**SYDNEY METRO MARTIN PLACE
STATION INTEGRATED STATION
DEVELOPMENT – SOUTH SITE**

**ACCESSIBILITY REPORT
STAGE 2 SSD DA**

**DOCUMENT REFERENCE NUMBER
CSWSMP-MAC-SMA-AC-REP-000110**

Morris Goding Accessibility Consulting

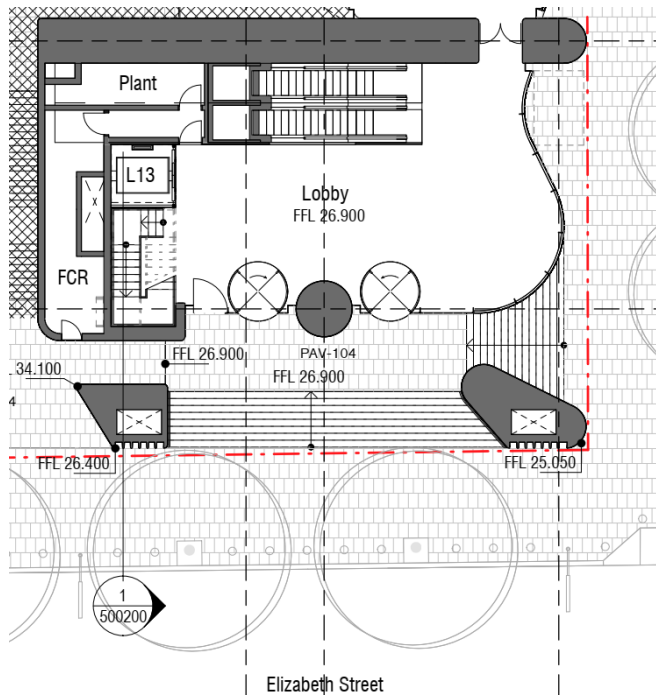
The first main entry doorway consists of a single-leaf hinged doorway. The latch-side clearances on both the internal and external sides of the doorway will not comply with AS1428.1(2009). However, the hinged door will be auto-operated. This will mean that users will not need to manually operate the door themselves.

So, a given user, upon the door leaf automatically opening, could simply pass through the doorway. This, in turn, will mean that the door will not require AS1428.1 latch-side clearances.

The second main entry doorway on Ground Level consists of a set of revolving doors. This set of revolving doors is located immediately adjacent to the first, hinged main entry door.

Revolving doors are not deemed to be accessible under AS1428.1(2009). However, this particular set of revolving doors is located immediately adjacent to the auto-operated hinged door.

Under Figure D3.2 of the DDA Access Code 2010 / BCA, these two doorways can be considered to be one 'entrance'. Because the auto-operated hinged door will be accessible, the entrance, as a whole, will be deemed to be accessible for the purposes of compliance with DDA Access Code 2010 / BCA.

The third main entry doorway on Ground Level consists of a separate set of revolving doors. This entry doorway is located at a distance of approximately 3 metres from the first-mentioned set of revolving doors. This latter set of revolving doors would be classified as a separate entrance.

This latter set of revolving doors would similarly not be considered an accessible entrance under AS1428.1(2009). Even so, the provision of one accessible main entrance out of two entrances is permissible under clause D3.2(2)(a) of the DDA Access Code 2010 / BCA.

In sum, there are, under the DDA Access Code 2010 / BCA, a total of two commercial main entrances on Ground Level. Of those main entrances, one main entrance is deemed to be accessible. This arrangement meets the requirements of the DDA Access Code 2010 / BCA.
